RE: Becker v. Aqua Missouri, Inc.; Case No's. SC-2007-0044 and SC-2007-0045

**SURREBUTTAL TESTIMONY**

RE: Lake Carmel Subdivision  
Wastewater Treatment Improvements  
Response to PSC Testimony

**Lake Carmel Lagoon Volume Confirmation  
For  
Jason Becker**

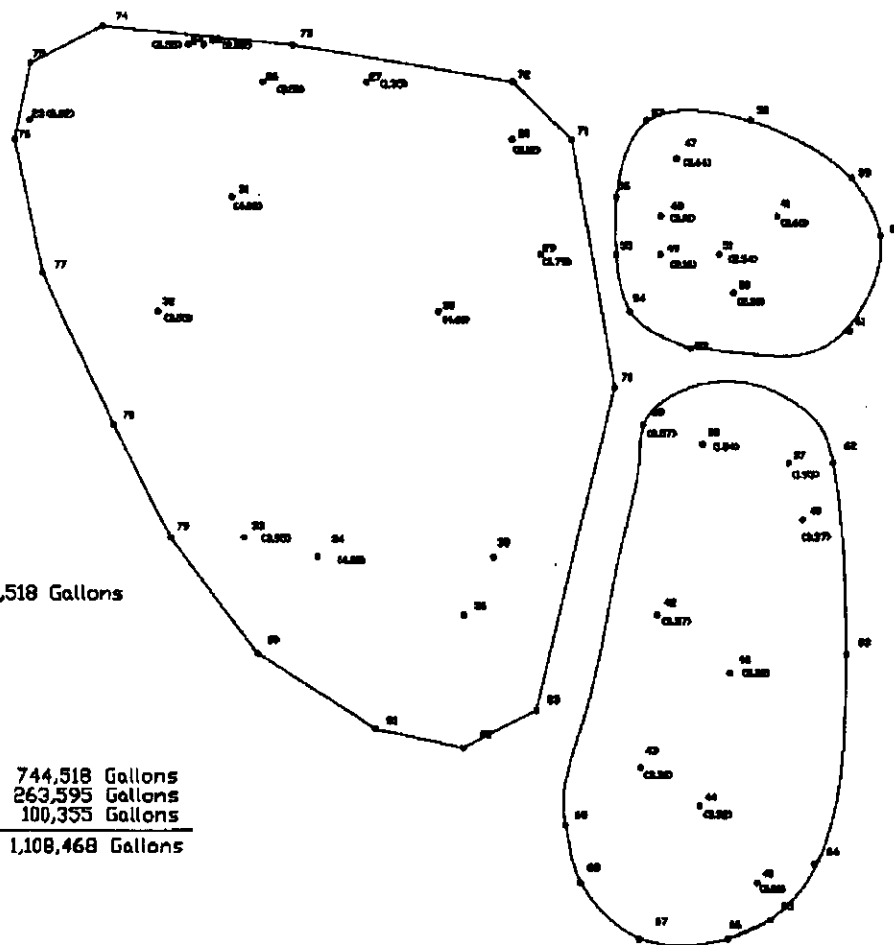
CELL #1 Area = 0.726 Acres  
 Average Depth = 3.147 feet  
 Volume = 2.285 Acre-Feet = 744,518 Gallons

1,108,468 Gallons

CELL #3 Area = 0.115 Acres  
 Average Depth = 2.675 feet  
 Volume = 0.308 Acre-Feet = 100,355 Gallons

CELL #2 Area = 0.282 Acres  
 Average Depth = 2.869 Feet  
 Volume = 0.809 Acre-Feet = 263,595 Gallons
